Powertex Fashion Limited (Relocation)

Dr. Panjabali-Dr. Assaduzzaman Industrial Park, Kathora, National University, Gazipur
(23.948446N, 90.363503E)

6th January 2019

Executive Summary

High stress column |

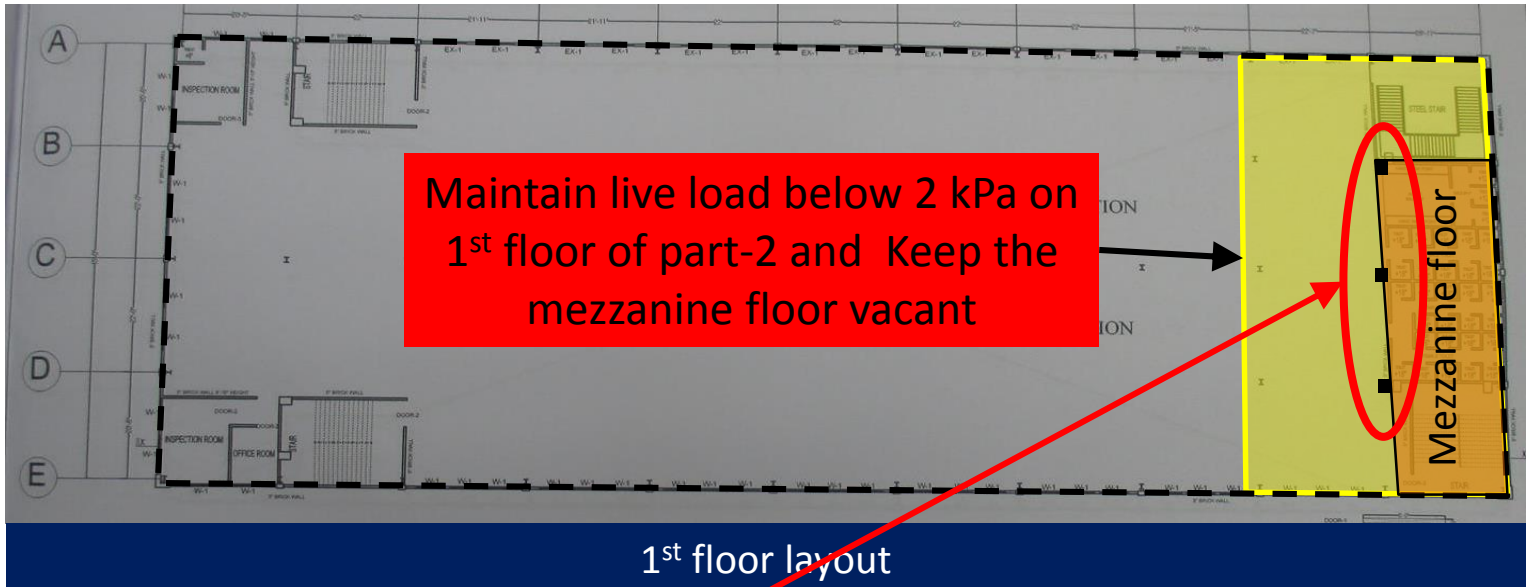
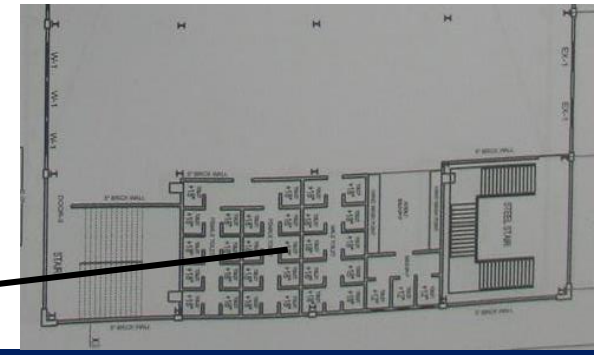
5000 ltr. Water tank

Approximate 450mm floor raised in toilet zone

Cursory calculation shows that the stresses of internal columns in mezzanine area exceed the normal design limit at ground level. Immediate actions mentioned in page-4 have to be followed and a Detail Engineering Assessment (DEA) to be commenced immediately based on in-situ material strength.

Item No.	Observation	Recommended Action Plan	Recommended Timeline
1	High stress column (Building-1)	Maintain floor live load below 2 kPa on first floor of part-2 and keep the mezzanine floor vacant until completion of DEA.	Immediate - Now
2	High stress column (Building-1)	Detailed Engineering Assessment (DEA) to be commenced following BNBC-2006 provision (please see the attach scope).	Immediate - Now
3	High stress column (Building-1)	Verify in-situ material strength.	Immediate - Now
4	High stress column (Building-1)	Building Engineer to review design, loads and stresses in all columns as part of a Detailed Engineering Assessment (DEA).	6-weeks
5	High stress column (Building-1)	Produce and actively manage a loading plan for all floor plates as per requirement of BNBC-2006.	6-weeks
6	High stress column (Building-1)	Carry out remedial works as per DEA recommendation.	6-months
7	High stress column (Building-1)	Continue to implement allowable floor loading plan.	6-months

Sub-beam layout

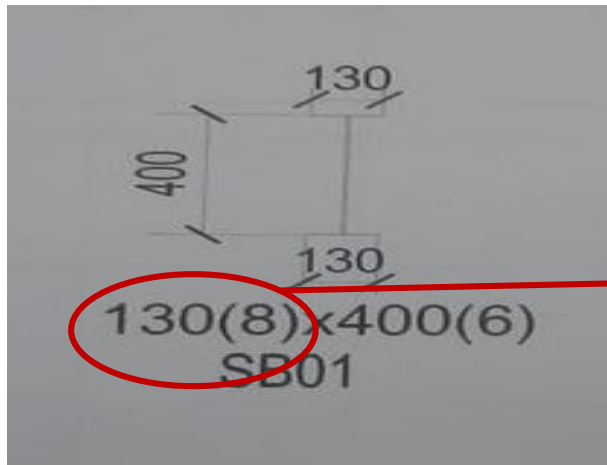
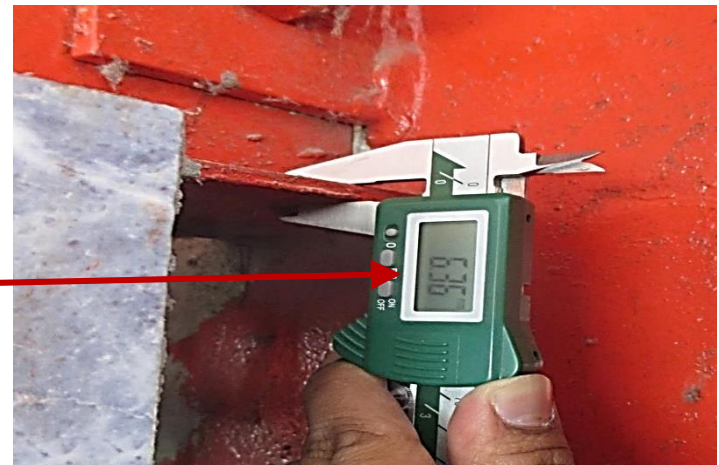
6 mm thick. flange of sub-beam

Flange thickness of sub-beam (SB-01) was found 6mm instead of 8mm

Roof layout

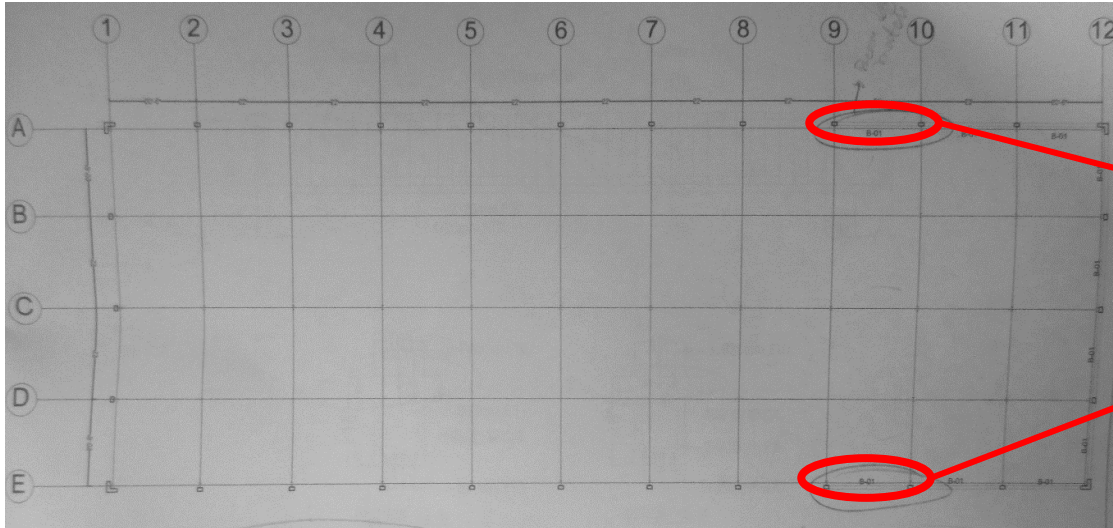
1st floor tie beam at the marked location did not match with as built drawing. Beam depth found 250mm where 450mm was shown in provided drawing.

1st floor tie beam layout plan does not match with the on site condition.

1st floor slab layout

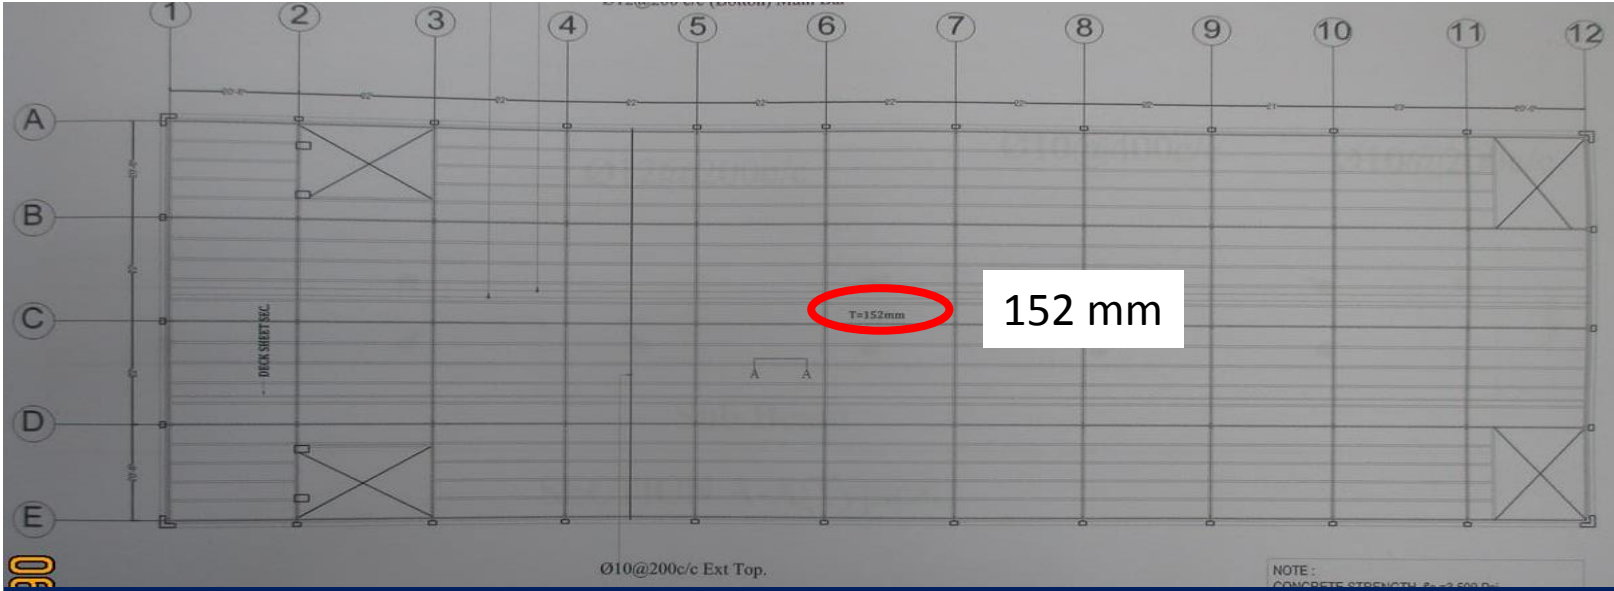
Slab thickness was found 125mm

Slab thickness was found 125mm in 1st floor level where 152 mm was shown on provided drawings.
